**HORIZONTAL DIRECTIONAL DRILL ANALYSIS
HORSE VALLEY ROAD CROSSING
PADEP SECTION 105 PERMIT NO. E50-258
PA-PE-0002.0000-RD & PA-PE-0002.0000-RD-16
(SPLP HDD No. S2-0157)**

**HORSE VALLEY ROAD CROSSING
PADEP SECTION 105 PERMIT NO. E50-258
PA-PE-0002.0000-RD & PA-PE-0002.0000-RD-16
(SPLP HDD No. S2-0157)**

RE: Sunoco Pipeline, L.P. Pipeline Project - Mariner East II
Horse Valley Road Horizontal Directional Drill Location (S2-0157)
Hydrogeological Re-evaluation Report
Toboyne Township, Perry County, Pennsylvania
RETTEW Project No. 096302011

PERRY COUNTY PENNSYLVANIA, TOBOYNE TOWNSHIP
S2-0157-16

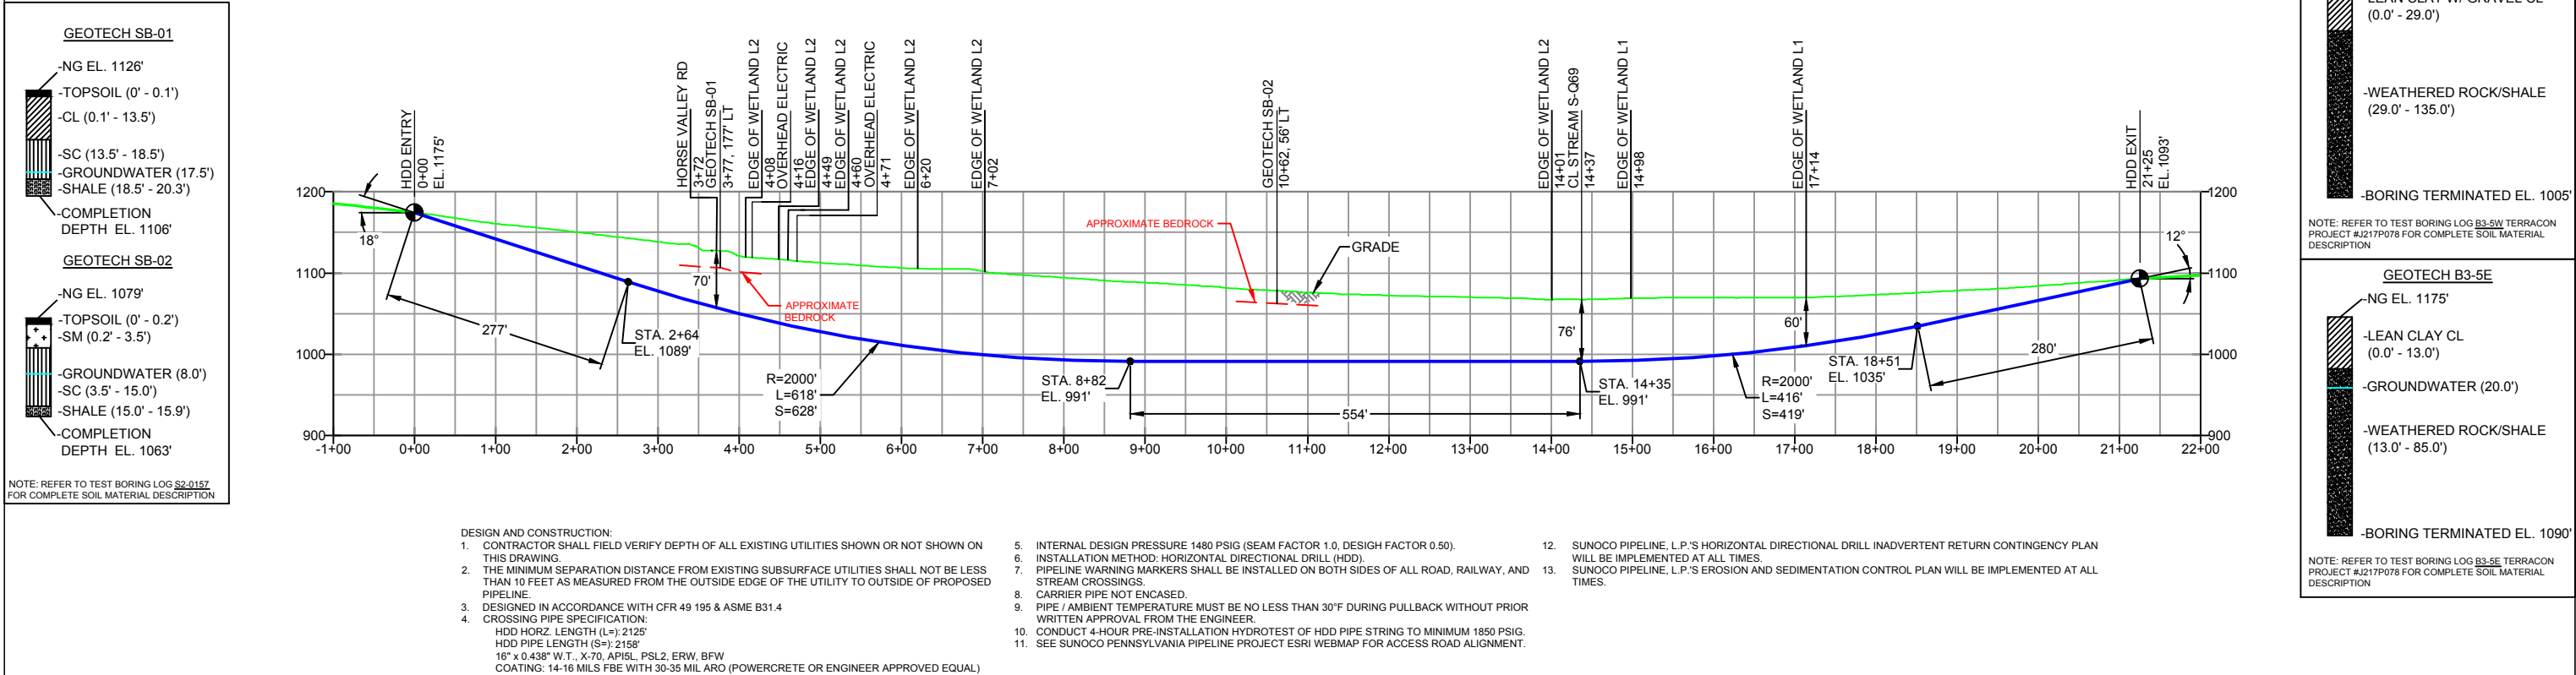
As shown on Figure 2, the redesigned HDD profile for the 20-inch pipeline is 613 ft longer, with a depth of cover below the streams and wetlands increased by 30-59 ft from the permitted design. In addition, the entry/exit angles have been increased allowing for a sharper and quicker descent into more competent rock. As shown on Figure 4 the redesigned HDD profile for the 16-inch pipeline is 528 ft longer, with a depth of cover below the streams and wetlands increased by 20-53 ft and designed for a sharp and quick entry and exit from the horizontal depth.

It is SPLP's intent to modify the original profile design and to pursue a deeper and longer HDD profile. Figure 1 and 3 in Attachment 2 presents the original HDD plan and profiles. Figure 2 and 4 in Attachment 2 present the revised HDD plan and profiles.

- Horizontal length: 2,170 foot (ft)
- Entry/Exit angle: 12-18 degrees
- Maximum Depth of cover: 110 ft
- Depth under Horse Valley Road: 76 ft
- Depth under stream: 84 ft
- Depth under wetlands: 60-80 ft
- Pipe design radius: 2,400 ft

- Horizontal length: 2,125 foot (ft)
- Entry/Exit angle: 12-18 degrees
- Maximum Depth of cover: 100 ft
- Depth under Horse Valley Road: 70 ft
- Depth under stream: 76 ft
- Depth under wetlands: 60-70 ft
- Pipe design radius: 2,000 ft
